J2126A-01

S E R V I C E N O T E

Agilent J2126A Transmission Test Set

Failure of Optical Covers

J2127A Instrument Panel - Reverse

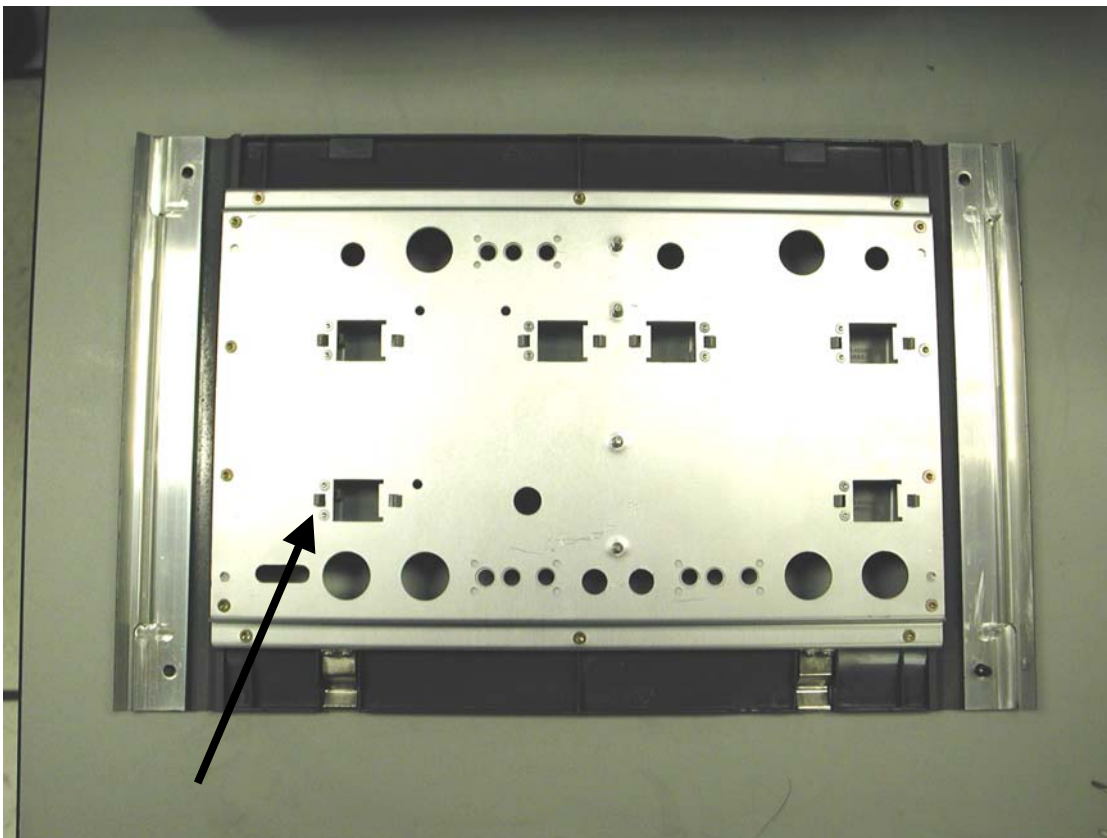
Early shipments of the J2126A Test Sets have a design problem with the optical covers, which makes them prone to cracking.

1. Remove the instrument top panel by unscrewing the four corner screws.
2. Lift off the instrument top panel.
3. Each optical cover is secured to the instrument top panel by a lip on each leg of the cover and also by two screws attached to the base of each cover. See the example arrowed in the illustration below.

Replace all existing covers with new, more rugged cover.

4. Remove the two screws from each cover first and then lever free one lip of the cover.
5. The cover should then lift free from the instrument panel.

6. Remove all the remaining covers.
7. Fit the replacement covers by performing the reverse of steps 4 to 6 taking care to position the covers as described below. Ensure the screws on the cover are tightened to a torque of 0.15nm maximum.

Instrument ESD Inserts

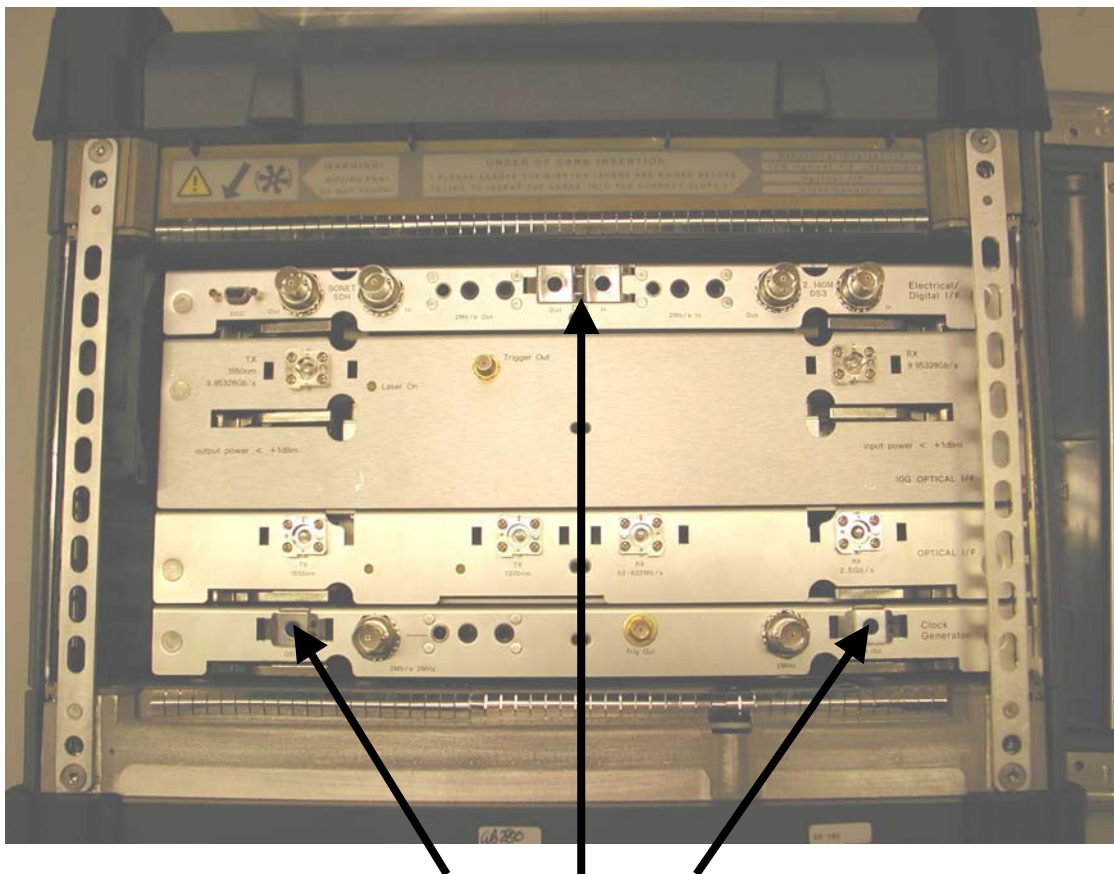
8. Before re-fitting the instrument top panel perform the following checks.
 - a) Check ESD inserts, as shown below, are properly aligned with the DS1 connector sockets.

- b) Replace any damaged inserts, using a suitable tool, such as narrow tweasers.
 - c) When removing any ESD inserts, lever out one side first and lift out the insert.
 - d) To fit a new insert locate one side of the insert first, then locate the other side.
9. Re-check the ESD insert alignment and then refit the instrument top panel.
 10. Ensure the screws securing the instrument top cover are tightened to a torque of 2.8Nm
 11. Finally, using a DS1 Bantam plug, check that there is no friction from the ESD insert as the plug is inserted into each of the DS1 sockets.
 12. End of procedure.
